Team Updates
Team UPDATE - 2012-01-13
Team UPDATE - 2012-01-10
Team UPDATE - 2012-01-13
GAME

Team UPDATE - 2012-01-10
GAME

Figure 4-8

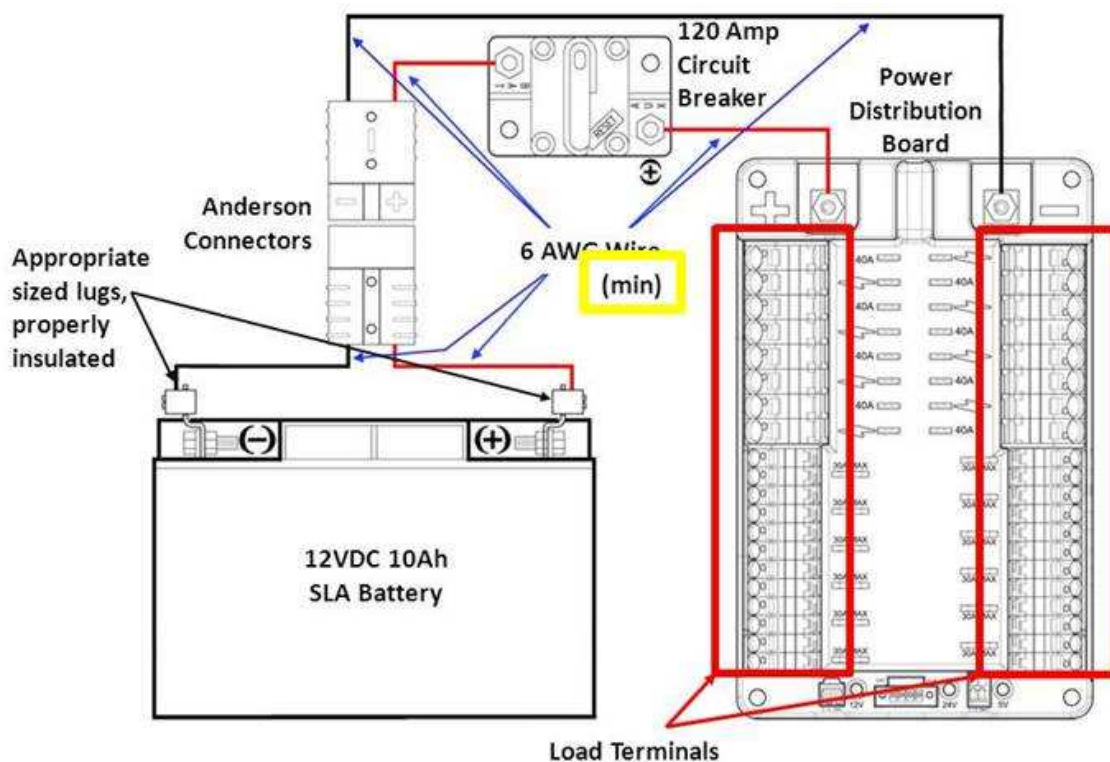
Figure 4-8 was revised to allow wire larger than 6AWG between the battery terminals and the Power Distribution Board terminals.

Figure 4-3

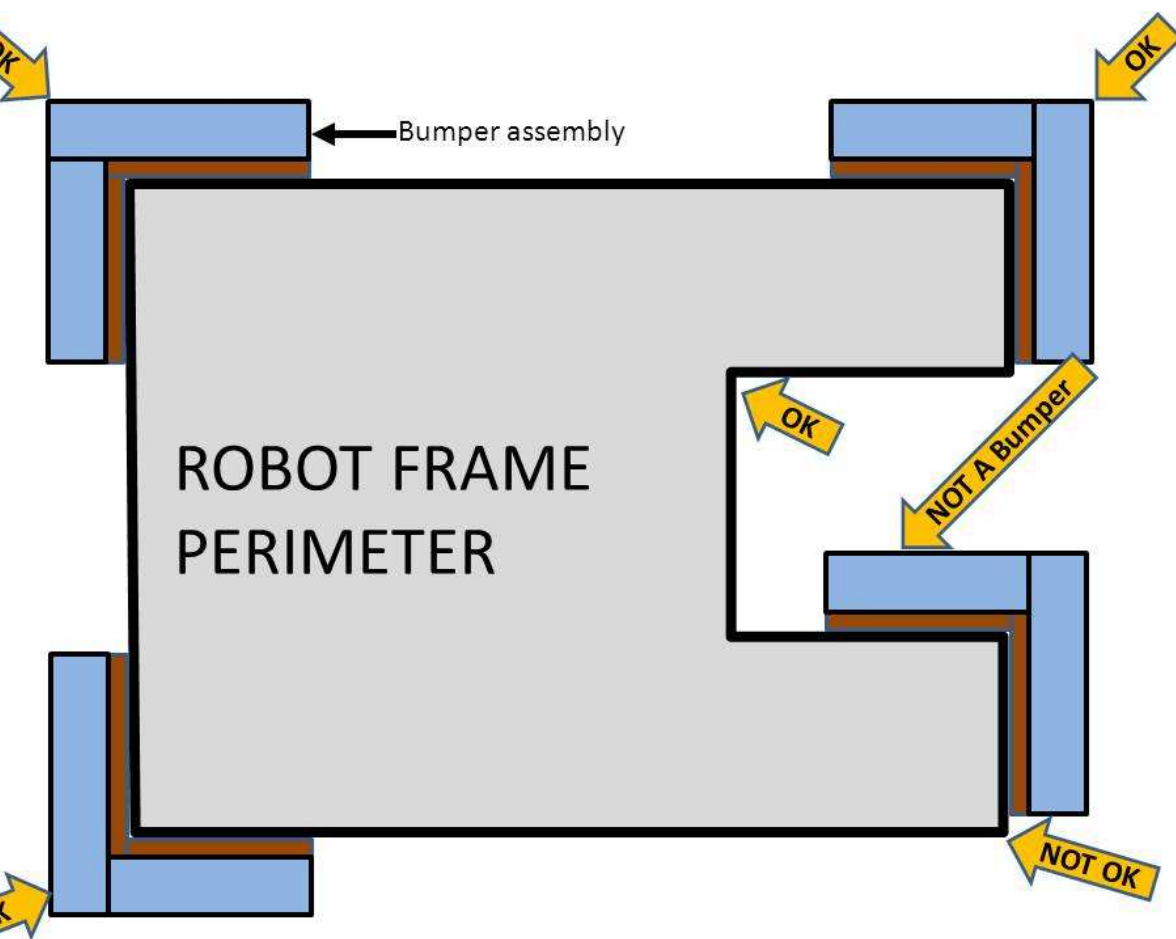
Figure 4-3 has been revised to clarify that example padding is legal, but not considered an official Bumper based on its placement.
